**WILLIAMS STATE SERVICE CENTER
INTERIOR RENOVATIONS
DOVER, DELAWARE
DBF #586B031.S01 ❖ OMB/DFM# MC3512000003
JANUARY 4, 2013**

ADDENDUM NO. 2

SK-3

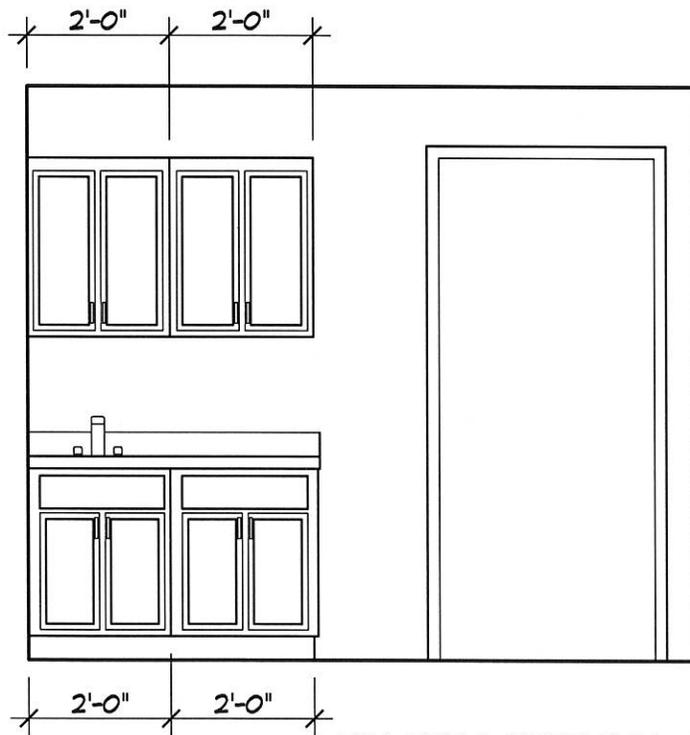
- Item No. 9: Refer to attached sketch SK-3 for elevations for cabinets in Teaching Prep 306 and BF Room 304.
- Item No. 10: Clarification F15/A2.1: The 30" tall cabinets noted are above the work counter, the bottom of the cabinets shall be 54" AFF.
